TOWN OF NISKAYUNA
Planning Board and Zoning Commission
Agenda
August 8, 2022
7:00 PM

TOWN OF NISKAYUNA
Planning and Zoning Commission
Hybrid Meeting
Meeting Minutes
July 25, 2022

ITEM TITLE: RESOLUTION 2022-17: A Resolution for sketch plan approval of a 2-lot subdivision off of Empire Drive, SEQR determination and a call for a public hearing.

ITEM TITLE: RESOLUTION: 2022-18: A Resolution for sketch plan approval of a 2-lot subdivision at 2239 Van Antwerp Rd, SEQR determination and a call for a public hearing.

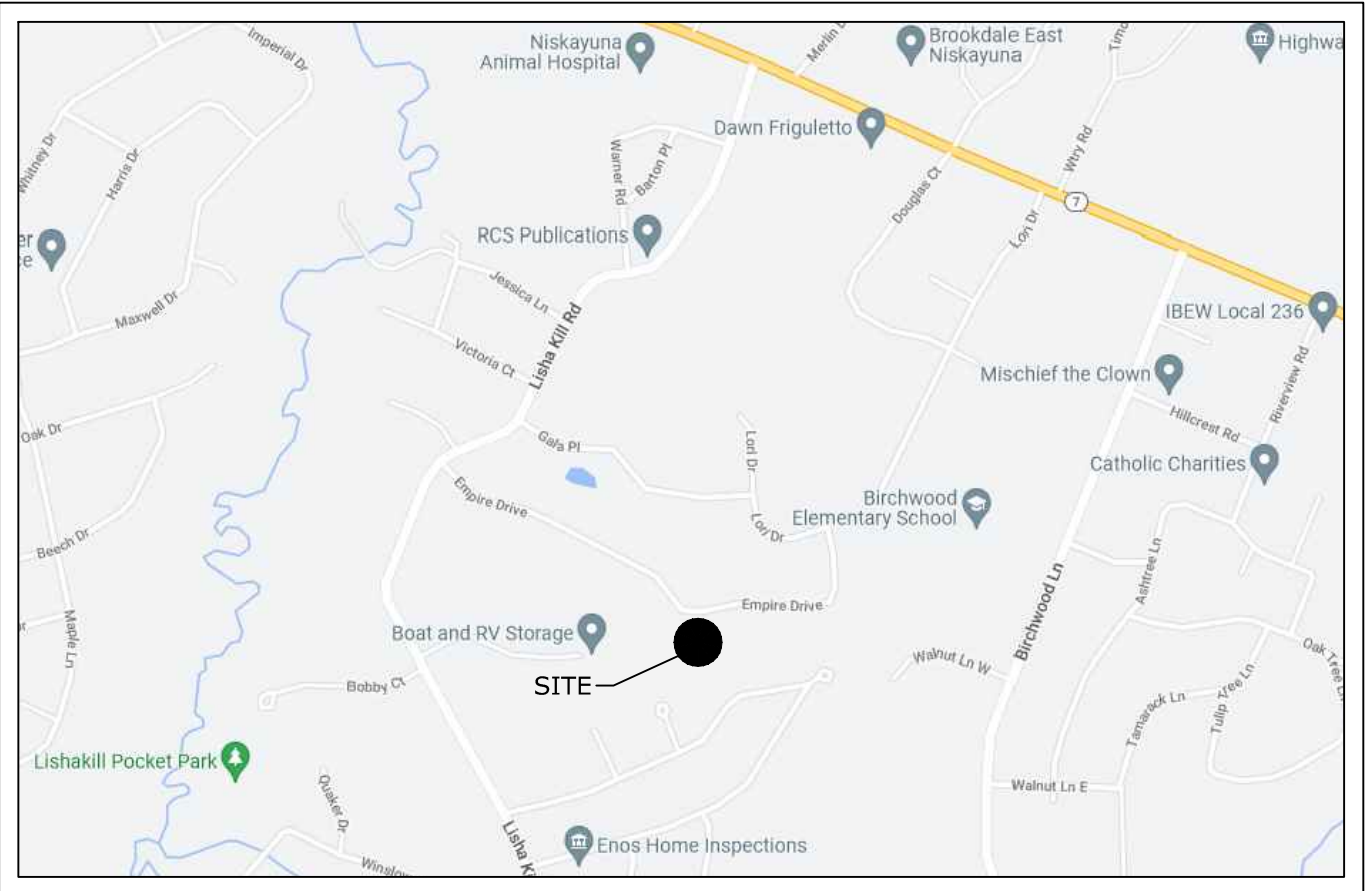
The original sketch plan drawing proposed two parallel contiguous driveways exiting from the stub off of Empire Drive running along the shared side property line of the two lots. Each driveway included a 20' wide turnaround at their intersection with the stub street so that snowplows would be able to turnaround.

7/11/22 Planning Board (PB) meeting – The property owner, Robert Joralemon, and Frank Palumbo of CT Male Associates presented the project to the PB. The PB did not like the proposal to have the Town snowplows turn around on the private driveways of the proposed subdivision. The PB asked for two alternate site plan drawings to be prepared. One version will include a traditional cul-de-sac at the end of the existing stub road. The second version will include a smaller “bulb” end to the existing stub road. The drawings were provided and are included in the packet for the meeting this evening.

7/25/22 Planning Board (PB) meeting – Mr. Joralemon and Mr. Palumbo presented two new site plan drawings that depicted the layouts that were requested by the PB at the 7/11/22 meeting. The PB preferred the second version of the two plans. It is entitled “Sketch Plan-Alt 2, 2 Lot Minor Subdivision, Empire Drive Lands N/F of Joralemon” by C.T. Male Associates dated June 30, 2022 with no subsequent revisions. The site plan includes small snow storage areas along each side of the stub road that intersects Empire Drive. Two completely independent driveways for the proposed two lots connect to a small semi-circular bulbous end of the stub road. Ms. Robertson noted that the Highway Superintendent preferred this version. The PB agreed on the following action items.

1. The PB to call for a public hearing (PH) at the 8/8/22 PB meeting (PH to be held on 8/29/22)
2. PB to make a SEQR determination at their 8/8/22 meeting
3. PB to take action on a resolution for sketch plan approval at their 8/8/22 meeting
4. Resolution to include the requirement that a sign stating “End of Public Road” be placed at the end of the stub road.

1. Require an easement on lot 1 for a potential future multi-use path that would connect the large forest to the northwest of the lot to Empire Dr. and destinations to the east such as Birchwood Elementary School.
2. Keep the limits of clearing as small as possible so that as many mature trees as possible may be preserved.

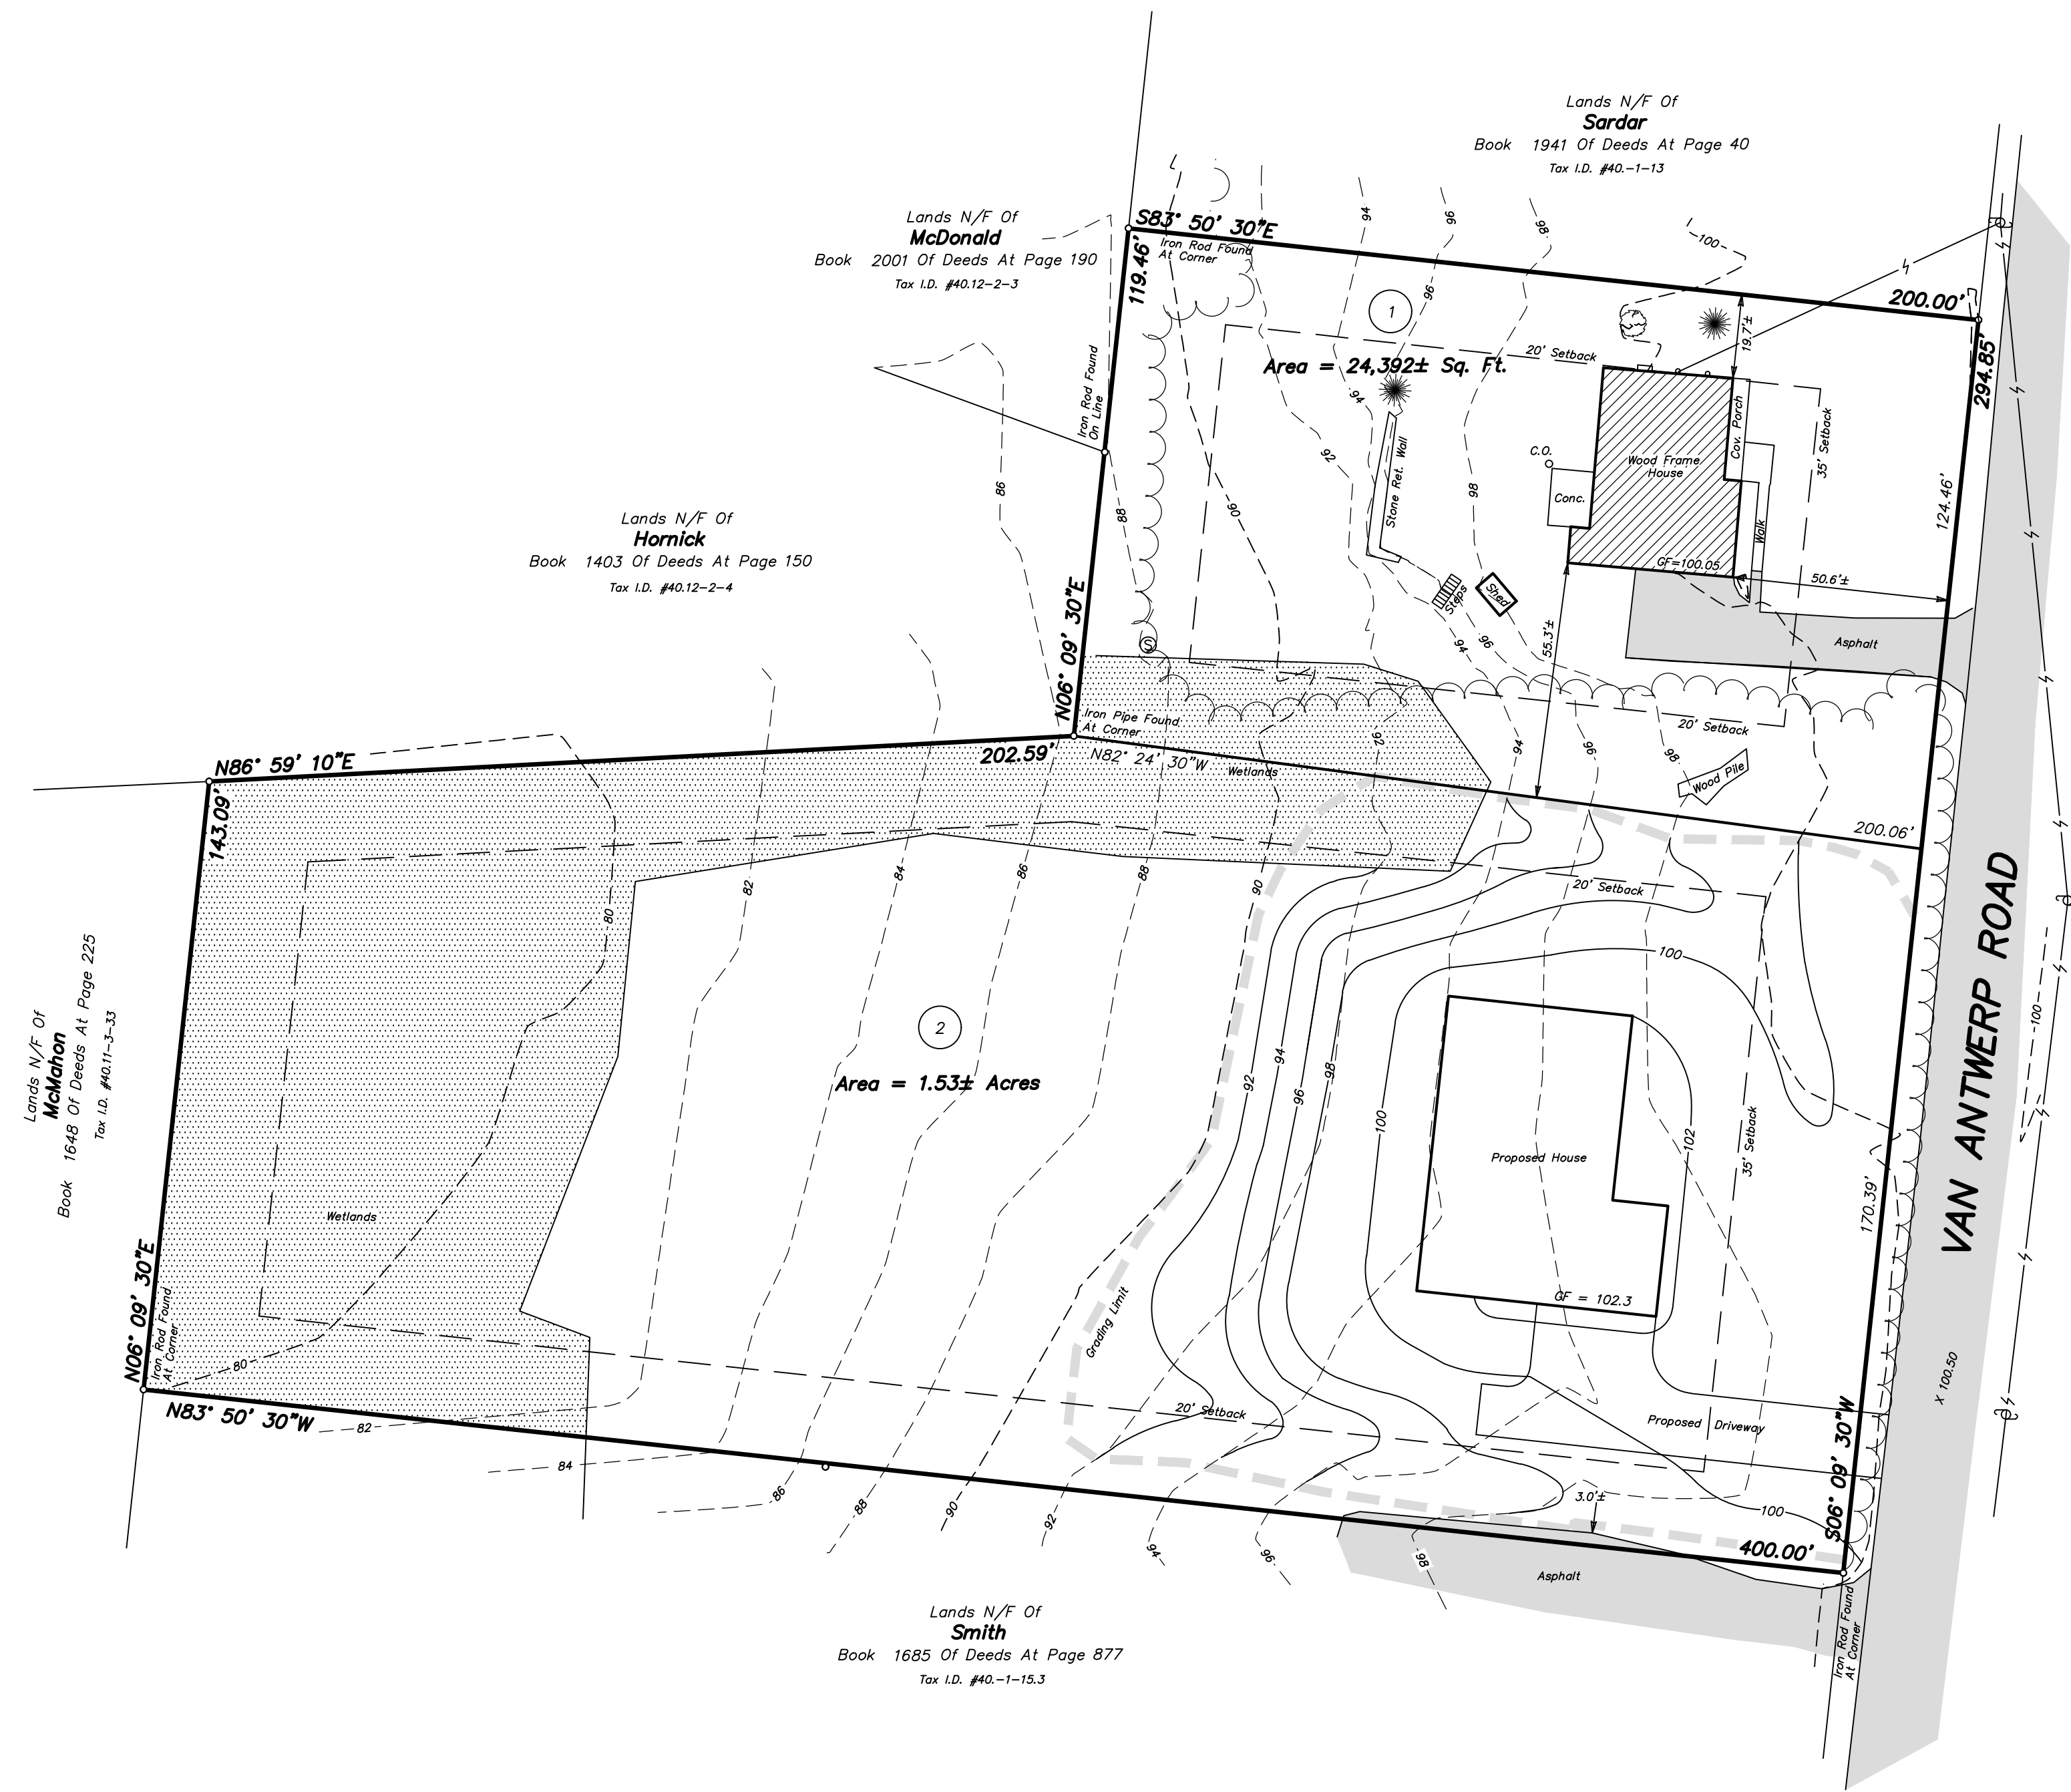
While the bulk requirements in the R-1 Zoning are easily met – the presence of the wetland will require further modification of the subdivision plan or an Army Corps of Engineers permit. Section 180-9 (O) states: “In general, wetlands and watercourses should not be filled, graded, or altered. The crossing of watercourses should be avoided to the maximum extent practicable. When protection of wetlands, watercourses, trees, steep slopes or other environmentally sensitive area is required, the location shall be shown on the erosion control plan and the method of protection during construction identified (e.g., silt fence, construction fence, stakes, etc.). A vegetative buffer (minimum of 25 feet) shall be maintained between disturbed areas and protected federal wetlands that are not proposed to be filled as part of an Army Corps of Engineers wetlands permit. In the case of state-designated wetlands, the adjacent area of 100 feet shall not be disturbed without a NYS Department of Environmental Conservation permit.” Therefore the 25 foot wetland vegetative buffer needs to be identified on the plans and no grading or disturbing of soils should be shown within the buffer.

There is also an issue with sewer or septic that should be examined during sketch plan approval. The existing sewer main is in the back of the property at 2239 Van Antwerp Road. Extending the public sewer main beneath the wetlands may be required or an onsite septic system should be reviewed (see aerial image in packet).

7/25/22 Planning Board (PB) meeting – a representative from Gilbert VanGuilder Land Surveyor, PLLC represented Mr. Jarosz and explained the project to the Board members. He mentioned that they would like to connect the future home to be located on the newly created lot to the existing public sewer. He also stated the wetlands on the property are Army Corps only. After additional discussion the PO called for a resolution for sketch plan approval at the 8/8/22 PB meeting, agreed on the following action items.

1. Revise site plan drawing to pull grading & limits of clearing away from 25' wetland buffer
2. Add sewer line to site plan and include easement boundaries

1. Retain as many existing trees on the site as possible, have Tree Council review limits of clearing and avoid / protect large trees during construction
2. Include a 10' wide easement along Van Antwerp ROW for a potential future multi-use path
3. Revise subdivision plan so there is no disturbance to wetlands and no grading / disturbance to the 25 foot wetland buffer
4. Utilize reasonable energy conservation practices and sustainable energy for new building.

1. Retain as many existing trees on the site as possible, have Tree Council review limits of clearing and avoid / protect large trees during construction
2. Include a 10' wide easement along Van Antwerp ROW for a potential future multi-use path
3. Revise subdivision plan so there is no disturbance to wetlands and no grading / disturbance to the 25 foot wetland buffer
4. Utilize reasonable energy conservation practices and sustainable energy for new building.
